**PLANNING BOARD
PORTSMOUTH, NEW HAMPSHIRE**

October 20, 2022

AGENDA

To: Planning Board
From: Beverly Mesa-Zendt, Planning Director
Stefanie L. Casella, Planner
Date: October 14, 2022
Re: Recommendations for the October 20, 2022 Planning Board Meeting

FILE	47442-00	DR	BMK	FB	-
CK	CK	CK	CK	CADFILE	47442-00_SITE PREP
					C-02

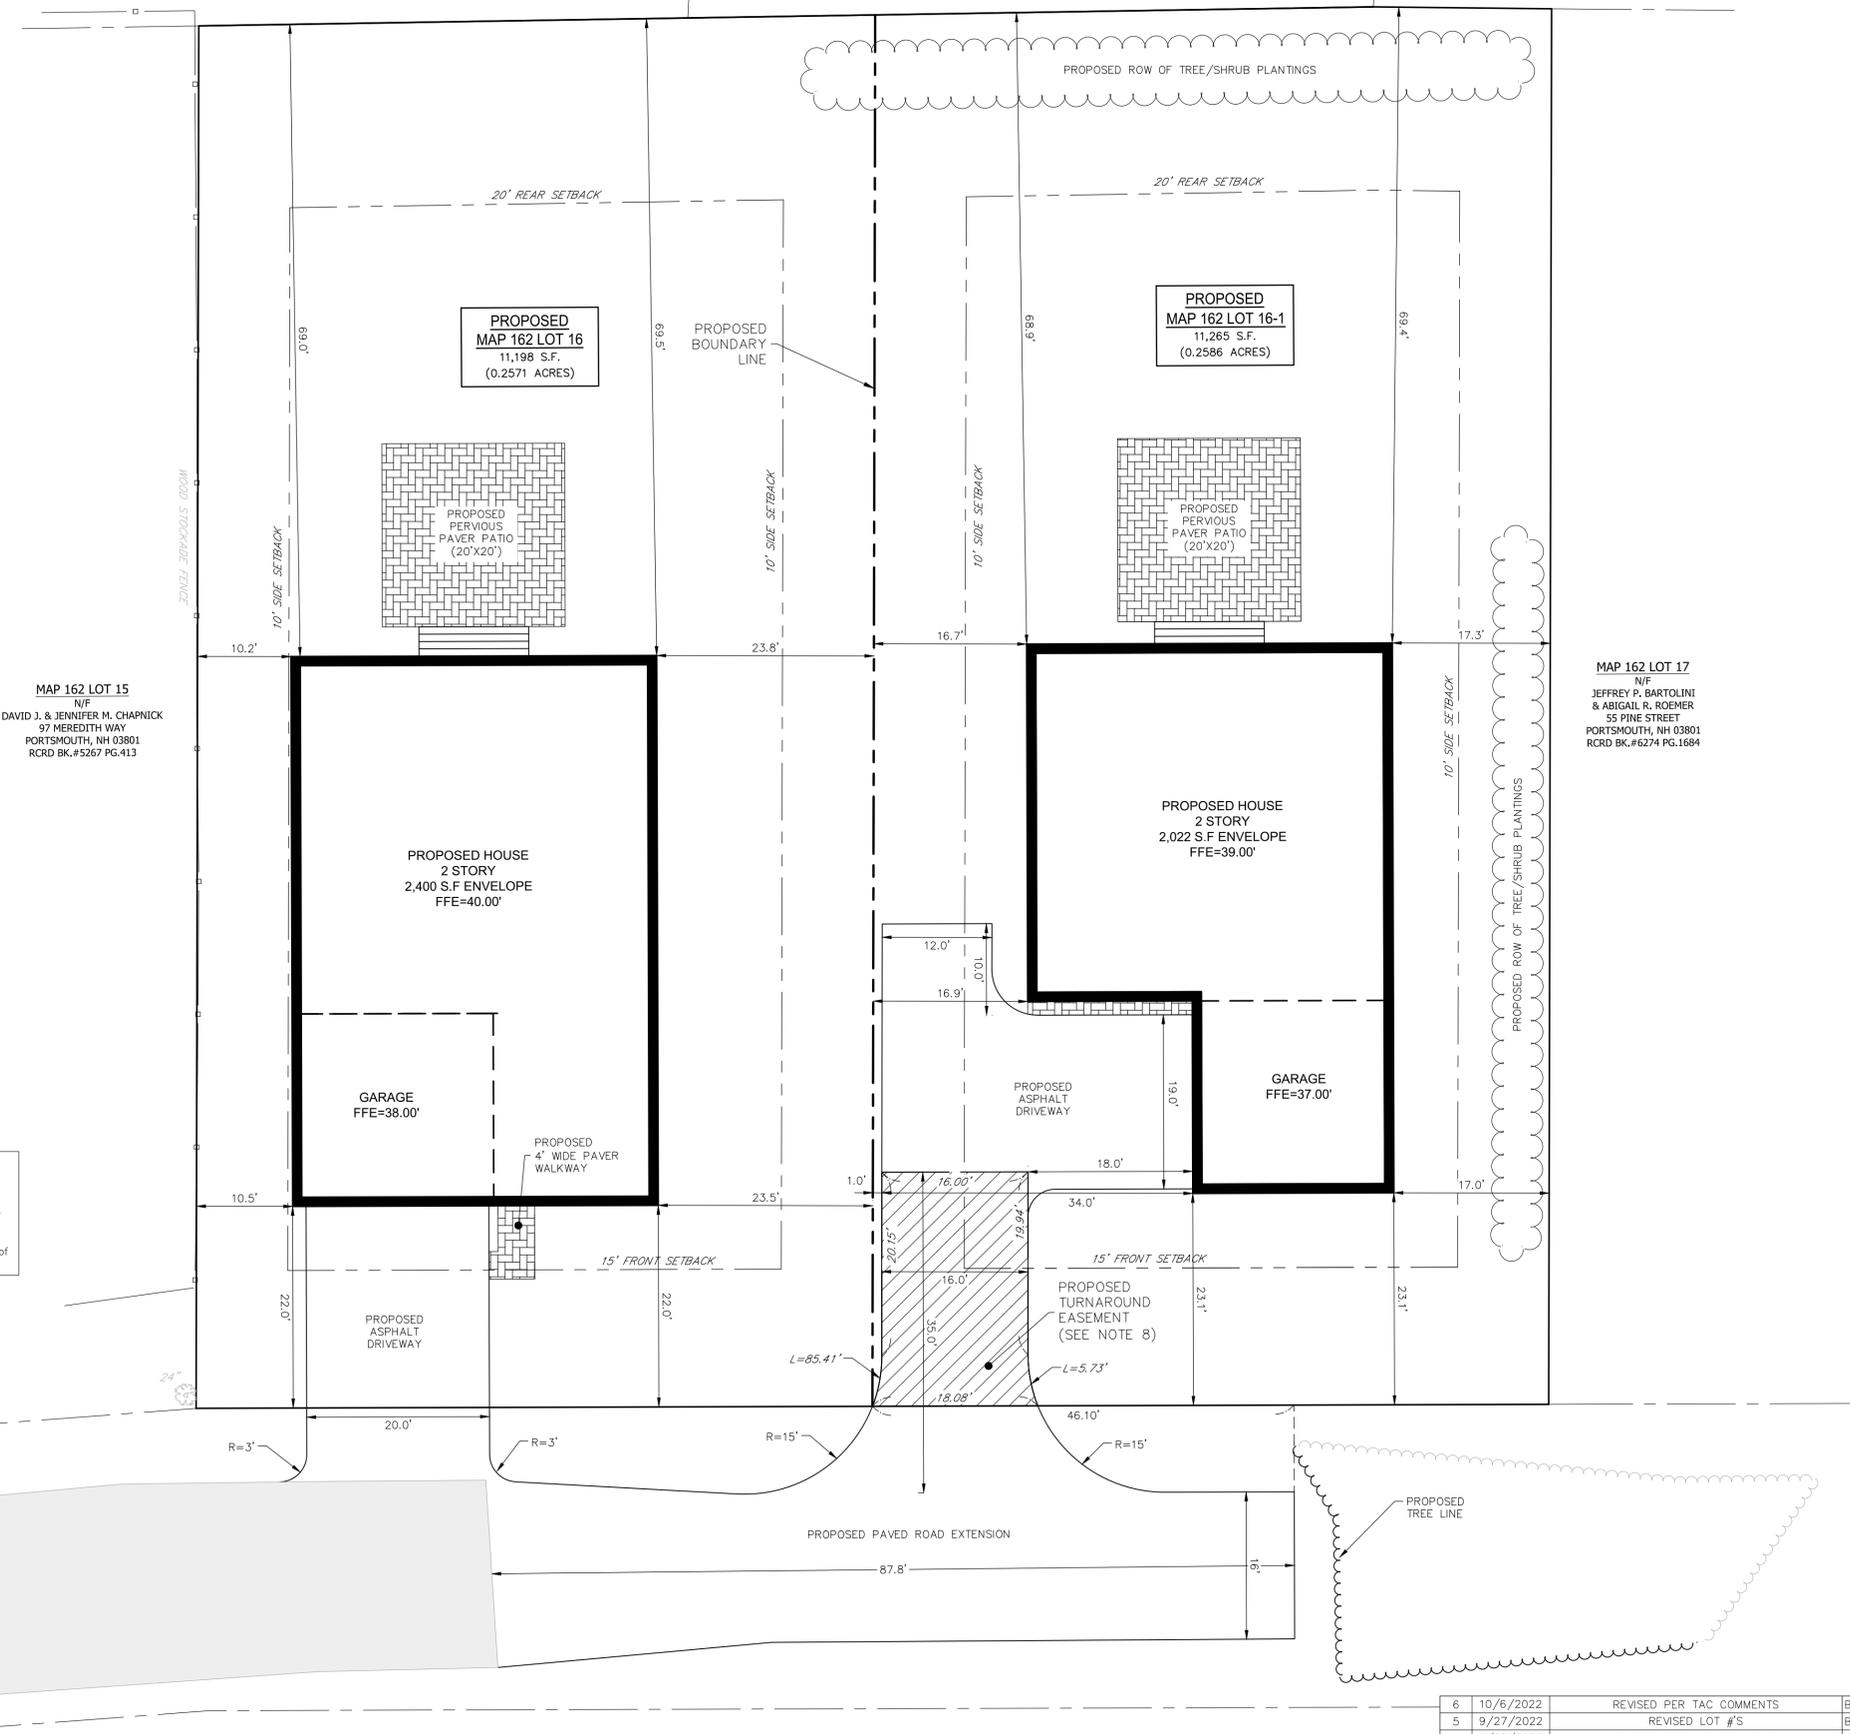
1. POI-3 of Sheet C-04 will be corrected and amended to DPW satisfaction.

Revised Note 10 on Sheet C-04.

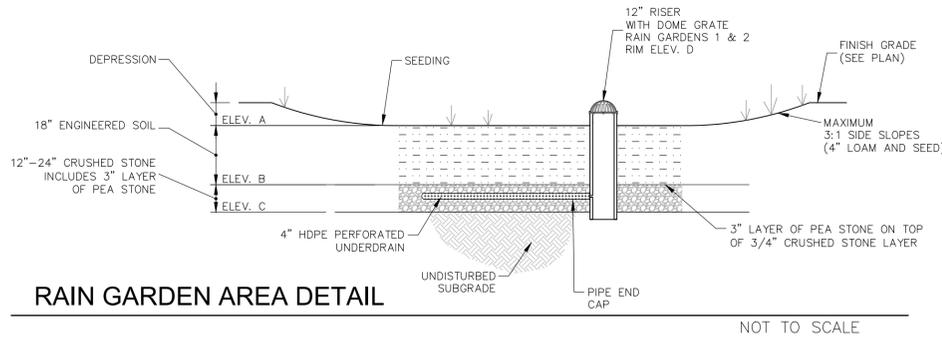
2. A note will be added to sheet C-07 detailing easement turnaround area will be constructed with Heavy Duty Pavement.

Revised Note 10 on Sheet C-07, also added Note 8 to Sheet C-03, Note 15 to Sheet S-02 & Note 14 to Sheet S-03.
